UNITED STATES PATENT AND TRADEMARK OFFICE

| APPLICATION NO. | FILING DATE | FIRST NAMED INVENTOR | ATTORNEY DOCKET NO. | CONFIRMATION NO. |
|------------------------|-------------|----------------------|------------------------|------------------|
| 10/568,787 | 08/23/2006 | Alan Gayne Emblin | 187540/US (461124-109) | 6382 |

| Office Action Summary | Application No. 10/568,787 | Applicant(s) EMBLIN, ALAN GAYNE | |

DETAILED ACTION

Fig. 3: Durbin (US 4,254,932)

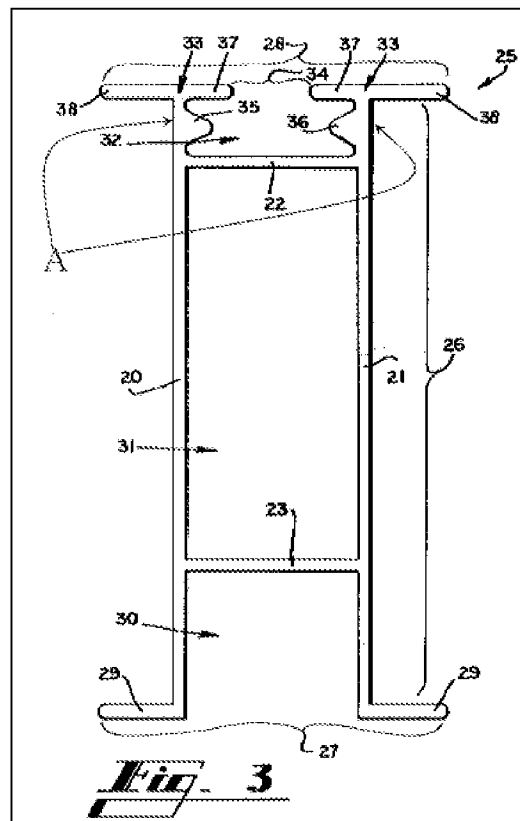
With regards to claims 60, 63, and 68: Durbin discloses a stud (25) capable of use in panel form work for solid filled walls, the stud comprising:

a head (22) formed as a strip (fig. 1) capable of being bonded and/or fastened to an inner face of a panel facing sheet, and

a pair of spaced, opposed flanges (A) formed along and extending away from a central portion of the head (22) the flanges defining a recess (32) with inwardly directed teeth (37) capable of engagement of a spacer element. Examiner notes the central portion of the stud/base is interpreted to be the middle portion along the longitudinal length of the stud.

With regards to claim 61: Durbin discloses the width of the head (20-21, 23, 29) is substantially greater than the spacing of the teeth (37) of the flanges on the central portion of the head.

With regards to claim 65: Durbin discloses two or more teeth (35-37) extending longitudinally along each flange (A) inside the recess (fig. 3).

With regards to claim 66: Durbin discloses each flange (A) has an out-turned terminal lip (38) (fig. 3) capable of guiding passage of the spacer element into the recess.

With regards to claim 67: Durbin further discloses the head, flanges and teeth are formed integrally as an extrusion (fig. 3). Note that head, flanges and teeth being formed from extrusion is considered product by process.

Fig. 3A: Dunn et al. (US 2002/0124508 A1)

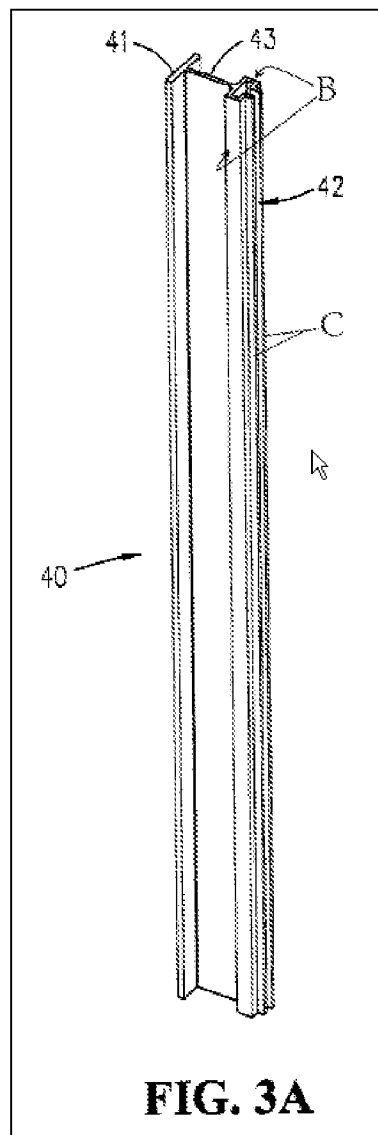
With regards to claims 60, 63, and 68: Dunn et al. discloses a stud (40) capable of use in panel form work for solid filled walls, the stud comprising:

a head (41) formed as a strip (fig. 3A) capable of being bonded and/or fastened to an inner face of a panel facing sheet, and

a pair of spaced, opposed flanges (B) formed along and extending away from a central portion of the head (41), the flanges (B) defining a recess with inwardly directed teeth (inwardly turned flanges) capable engagement of a spacer element.

With regards to claim 62: Dunn et al. discloses the width of the head (41) is approximately seven times the spacing between the teeth (inwardly turned flanges) of the flange on the central portion of the head.

With regards to claim 64: Dunn et al. further discloses a cross sectional configuration, formed by the strip and the pair of flanges, which is substantially T-shaped (fig. 3A).

With regards to claim 67: Dunn et al. further discloses the head, flanges and teeth are formed integrally as an extrusion (fig. 3A). Note that head, flanges and teeth being formed from extrusion is considered product by process.

With regards to claim 71: Dunn et al. further the width of the head of each stud is more than double the width of the recess formed by the teeth of the flanges (figs. 1B & 3A). Note that the teeth are part of the flanges.
